| Project Title: | Palen Solar Power Project - Compliance |
| Document Title: | Yuma clapper rail recovery plan |

YUMA CLAPPER RAIL RECOVERY PLAN

Letters and Memoranda Commenting
On the Draft Plan

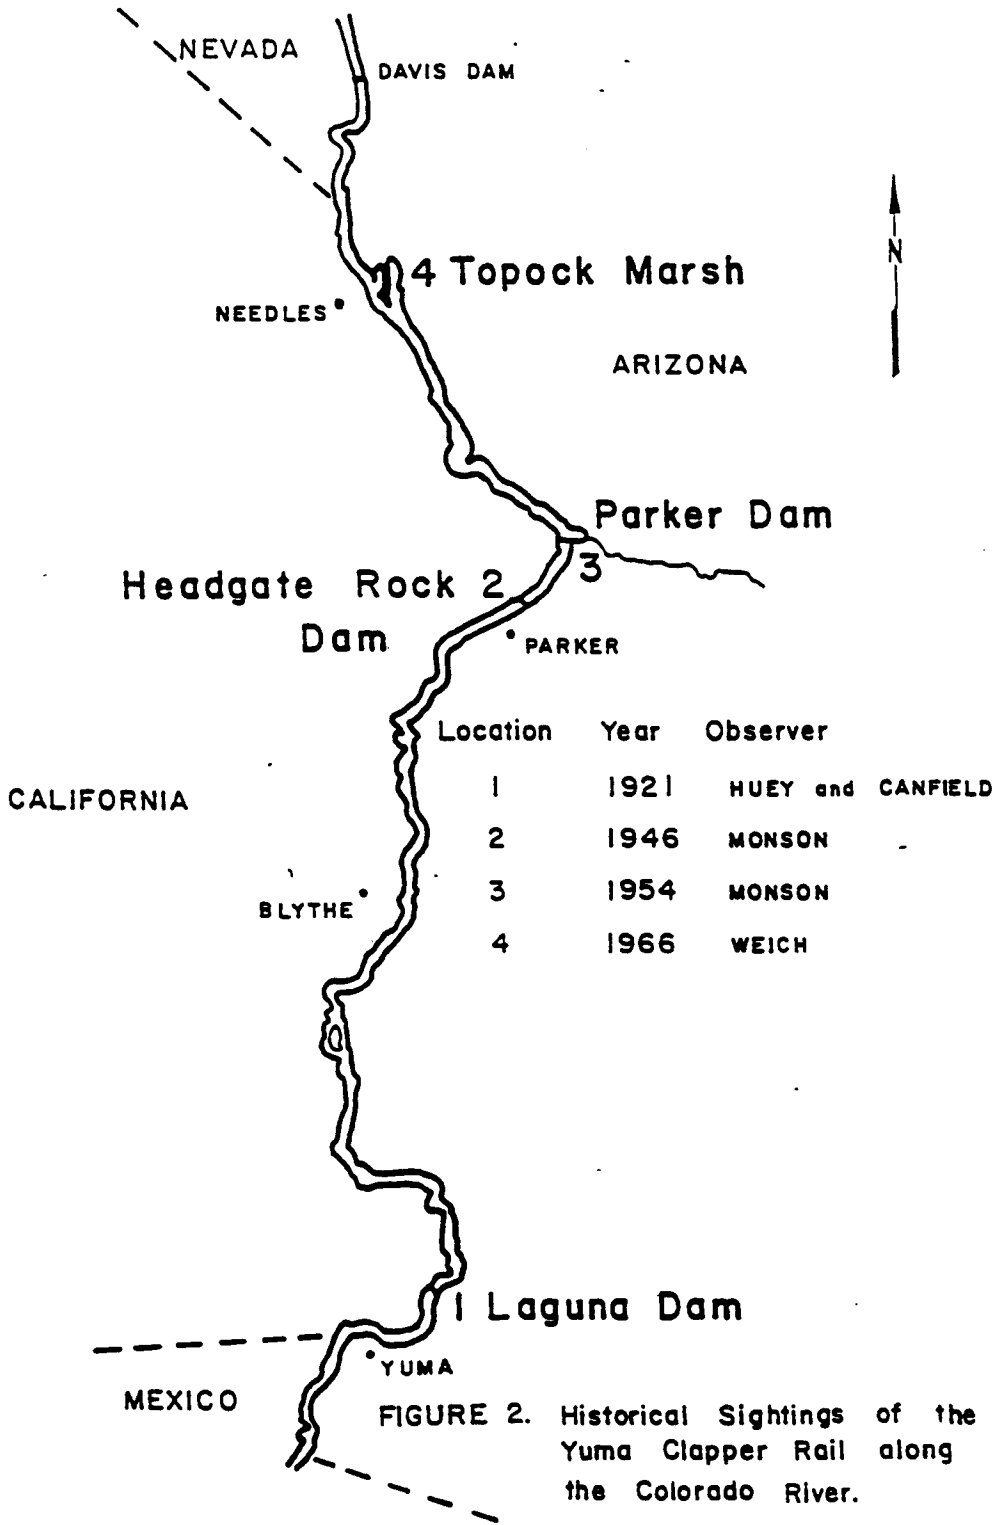
-13 Figure 2: There is no text reference to Monson's 1946 sighting indicated in the figure.

- L-8 Corrected
- L-9 Corrected
- L-10 Statement referencing no legal hunting season included
- L-11 Corrected
- L-12 Figures have page numbers
- L-13 Statement added
